# ADDENDUM NO. 1 FOR KUHIO HIGHWAY CONCRETE BARRIER INSTALLATION VICINITY OF LANIKAI STREET DISTRICT OF KAWAIHAU ISLAND OF KAUAI PROJECT NO. 56A-01-24M

# July 26, 2024

# Responses to Request for Information (RFI's/Questions) HIePRO Questions for solicitation B24003380 Kuhio Highway Concrete Barrier Installation, Vicinity of Lanikai Street Project No. 56A-01-24M As of July 19, 2024

| 7/22/24 / – Revise End Post Plan & Elevation  |  |  |  |  |
|---|--|--|--|--|
| ADD.12  |  |  |  |  |

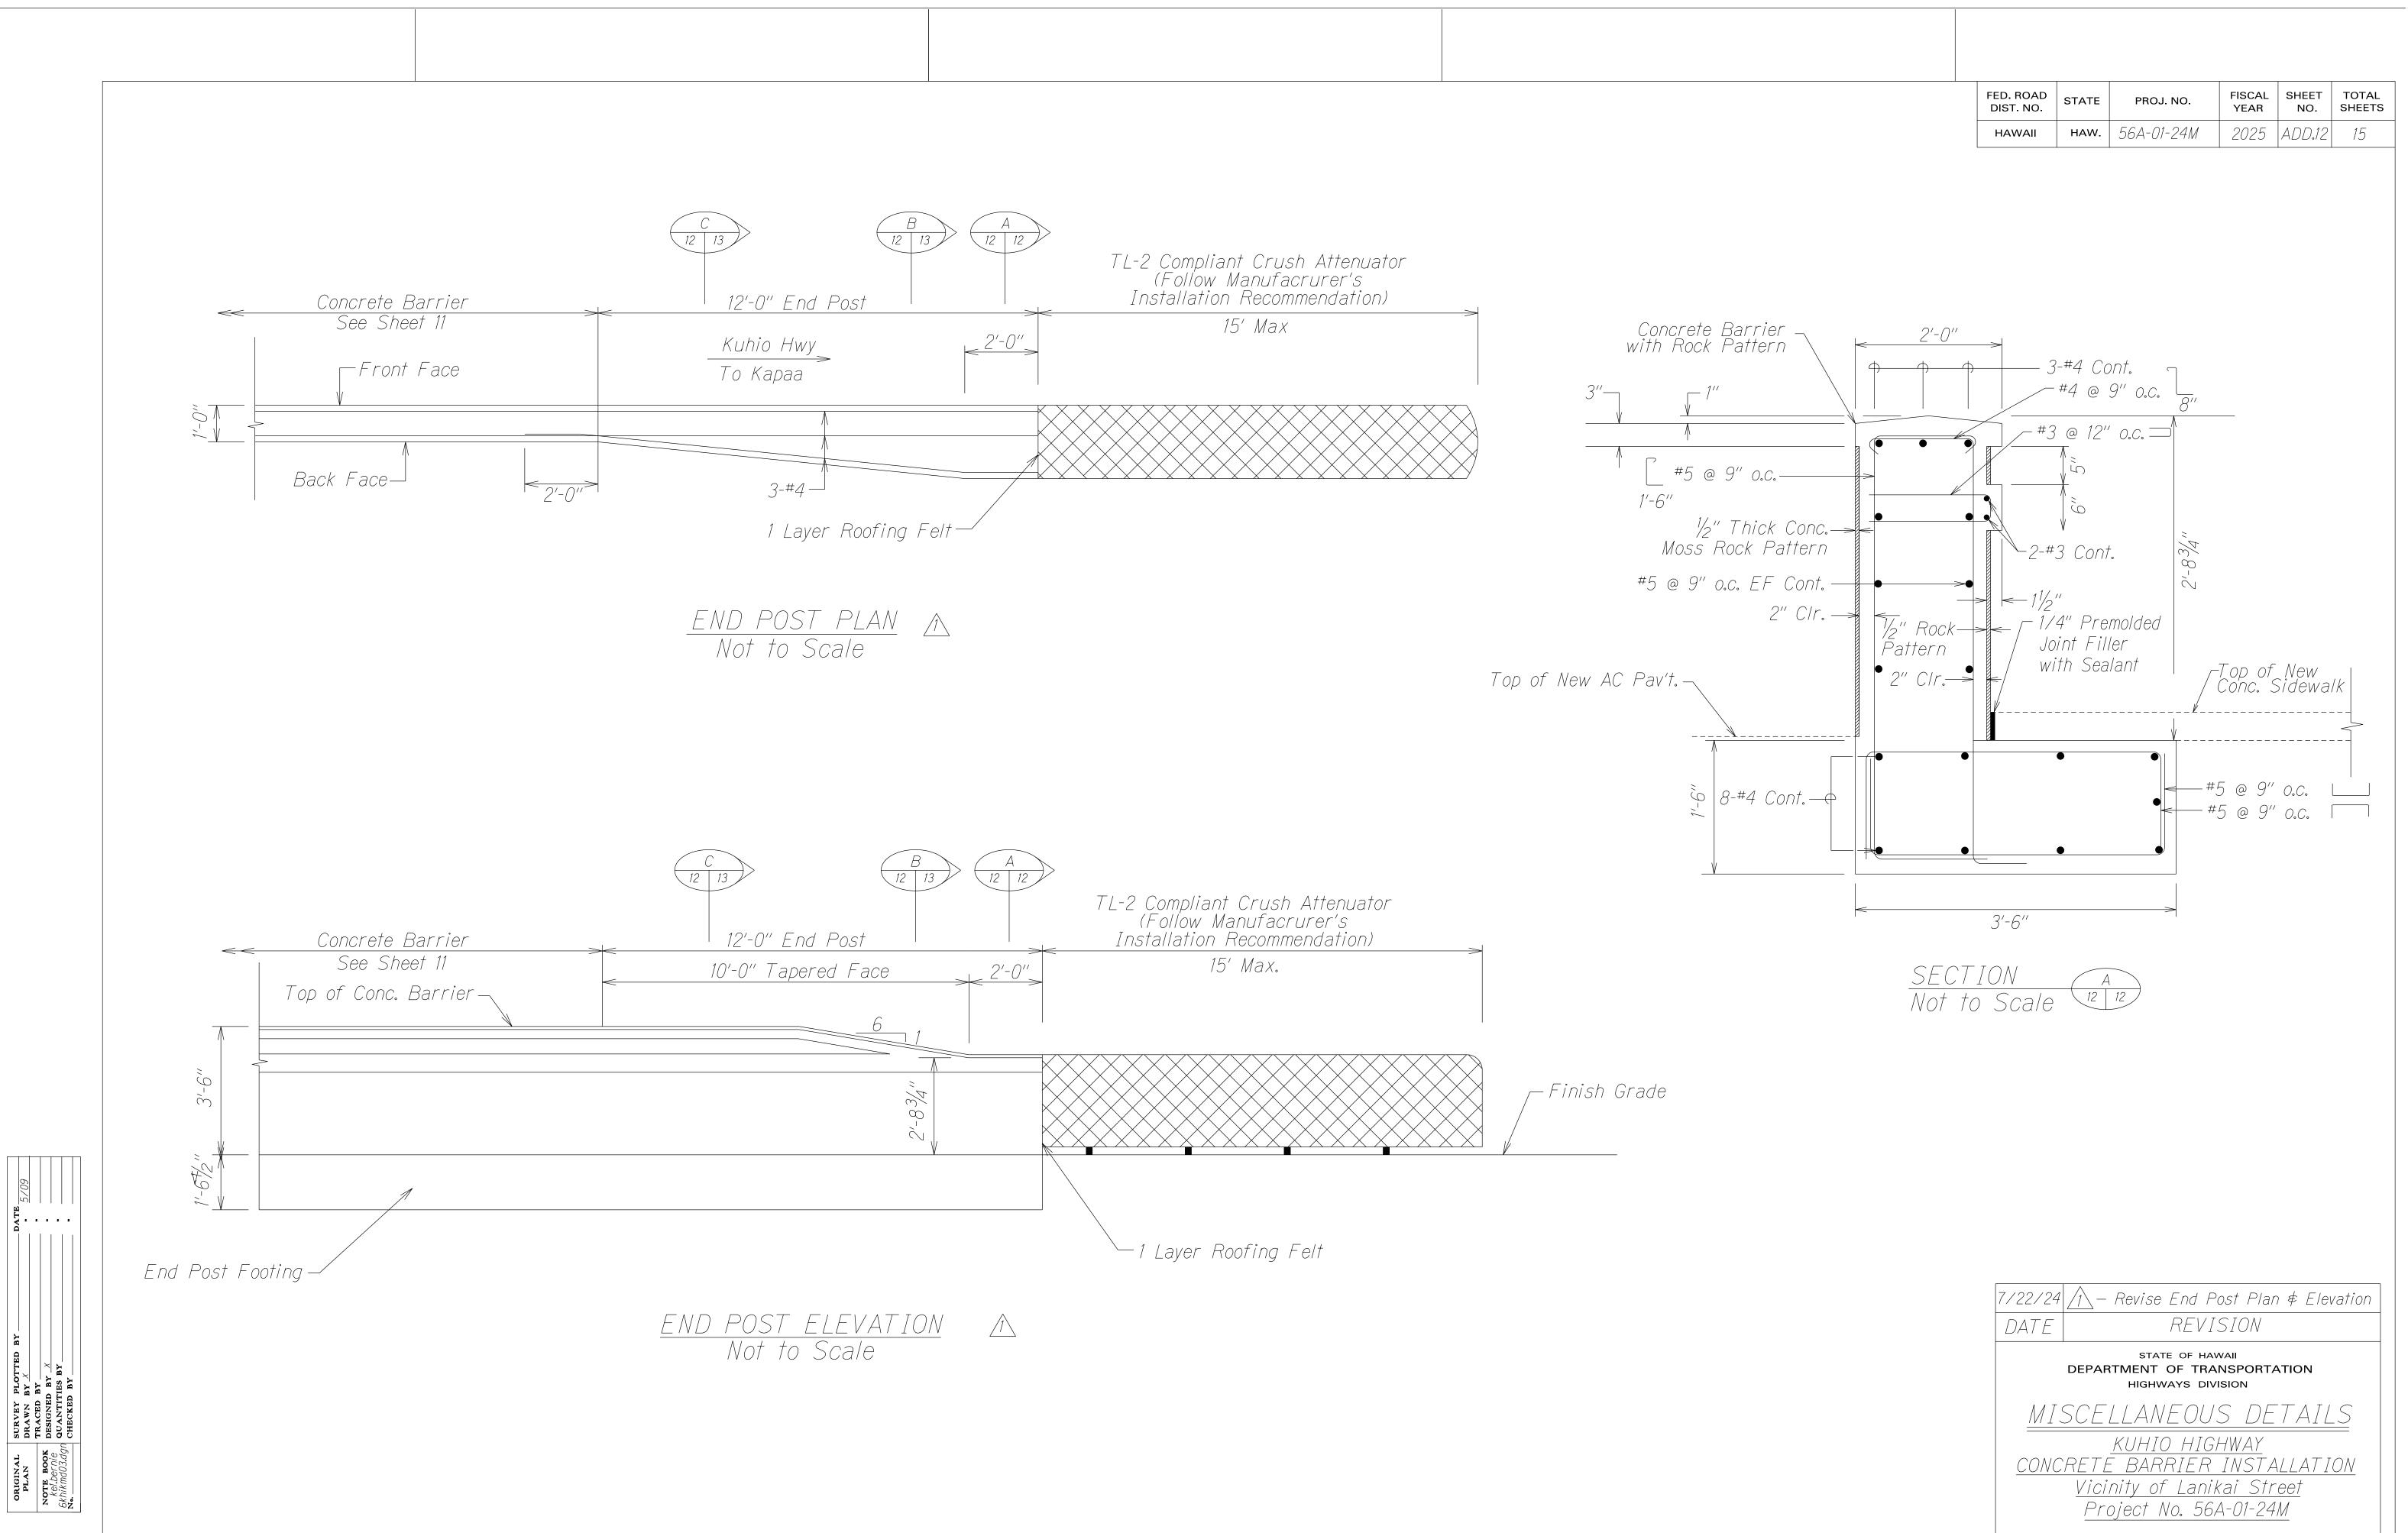
| 7/22/24 / – Revise End Post Plan & Elevation  |  |  |  |  |

| FED. ROAD<br>DIST. NO. | STATE | PROJ. NO.  | FISCAL<br>YEAR | SHEET<br>NO. | TOTAL<br>SHEETS |
|------------------------|-------|------------|----------------|--------------|-----------------|
| HAWAII                 | HAW.  | 56A-01-24M | 2025           | ADD.14       | 15              |

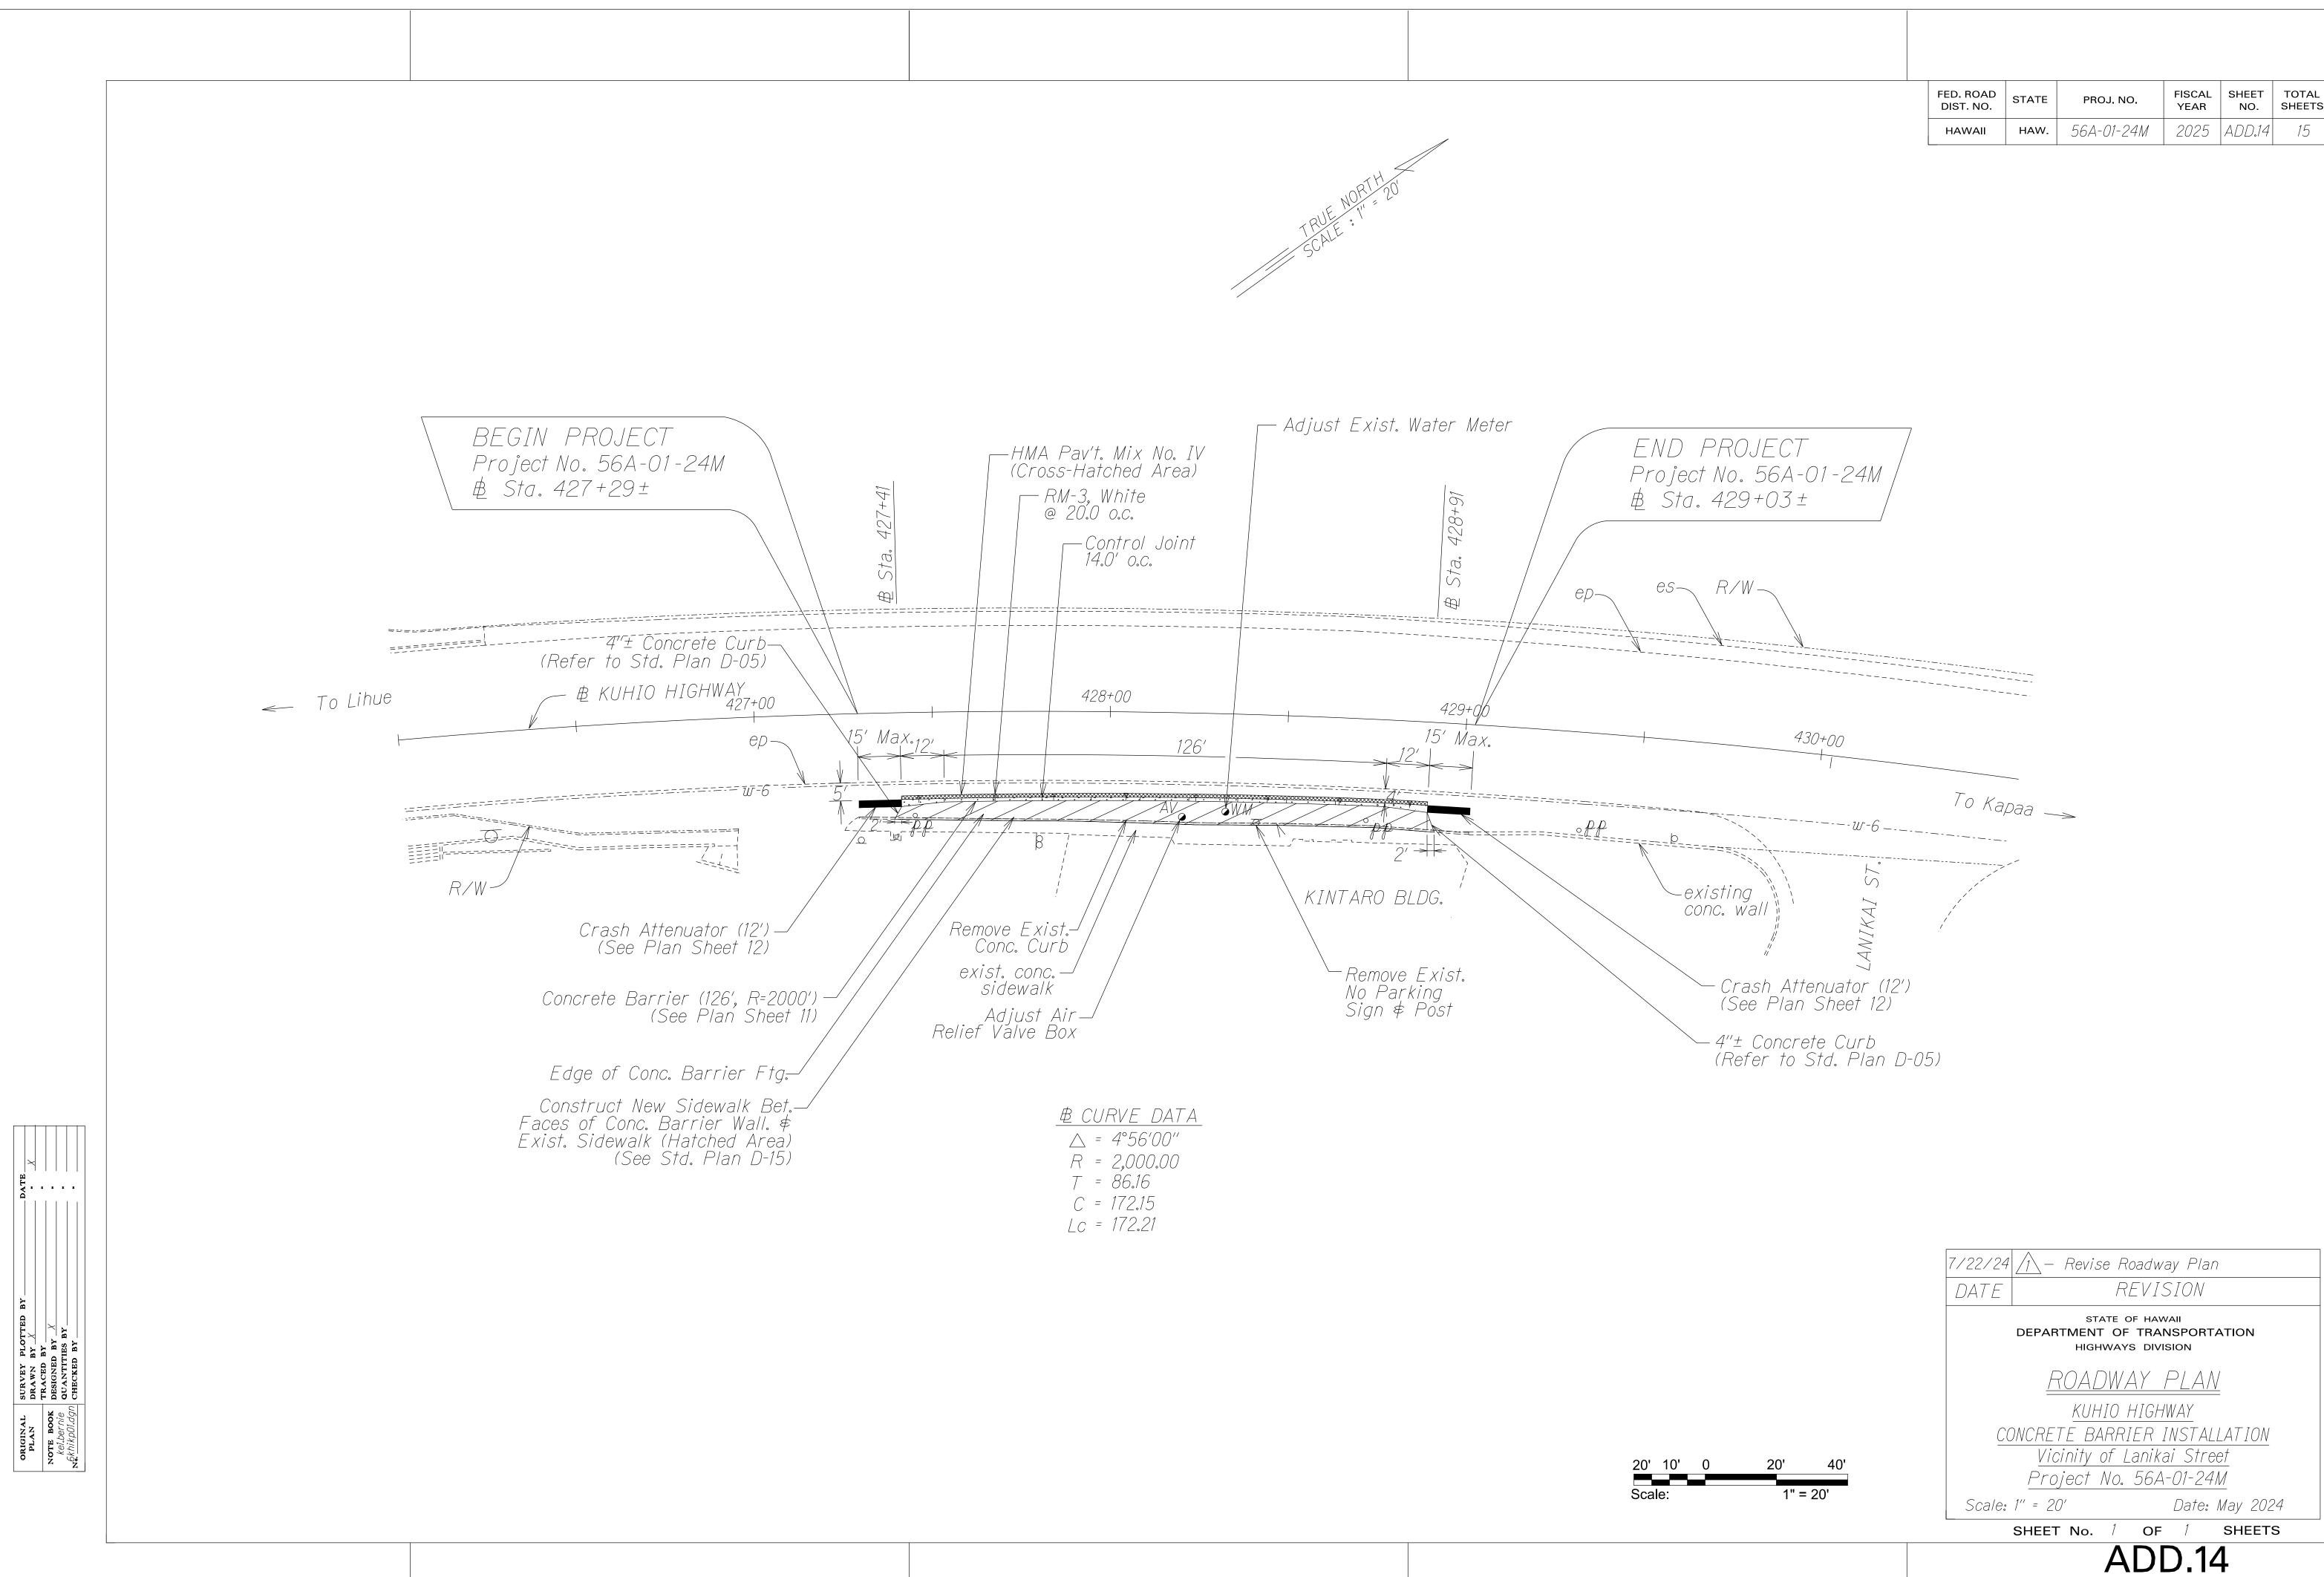
11. For Concrete Curb called out at 427+29 & 429+03 in front and side of crash attenuator - it is called out to be 6 inches high. Typically curbs in front and side of crash attenuators are 4 inches high to meet crash criteria of the crash attenuators, can you please clarify and provide a detail?

RESPONSE: HDOT will revise the Plans.
